Attachment C: Public Correspondence to Date

Submission to Planning Board Hearing on the Pedestrian Master Plan

Re: Public Hearing Draft of the Pedestrian Master Plan

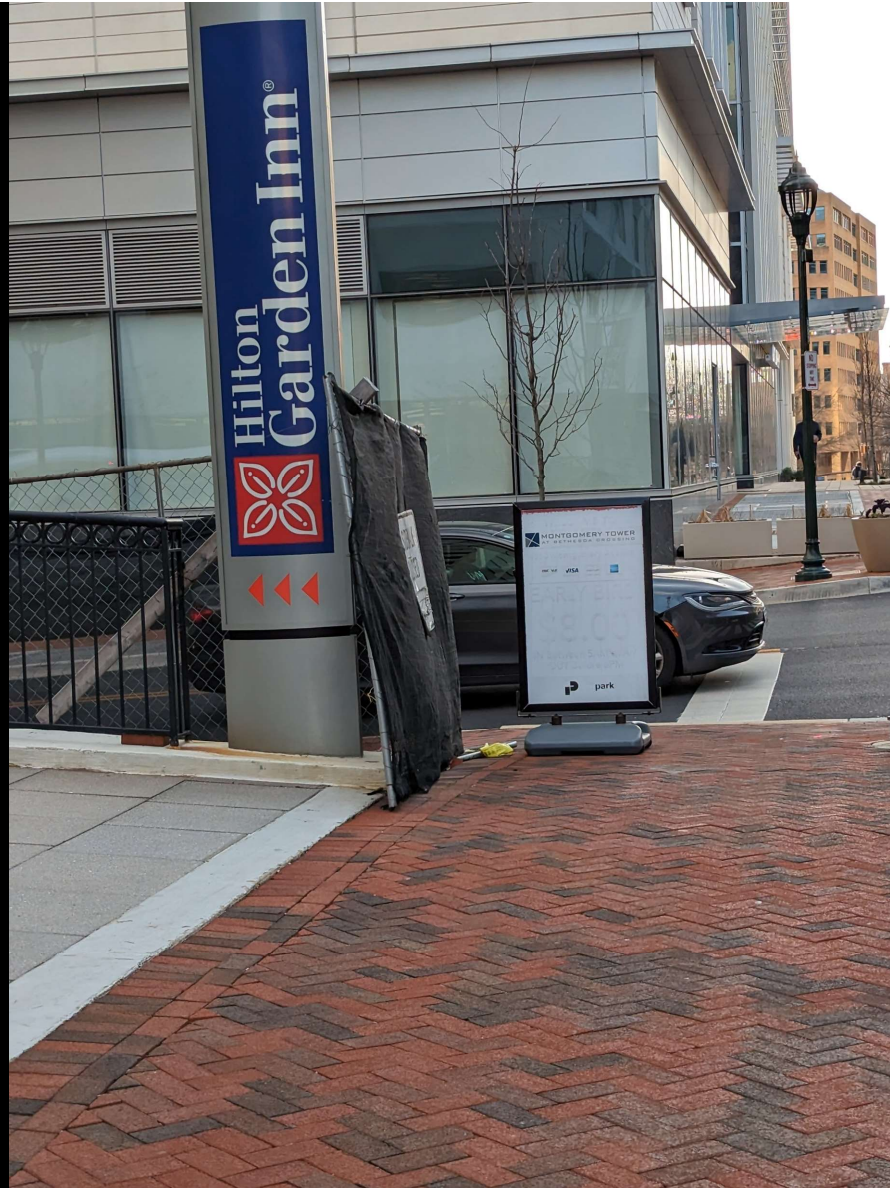
Montgomery Ave.
Signal pole in middle of
sidewalk

Bradley Blvd.
Phone pole in middle of
sidewalk

Bradley Blvd.
Phone pole and traffic
control box make for a
slalom course

Wisconsin Ave.
Driveway curbs present
tripping hazard and wheelchair
obstacle
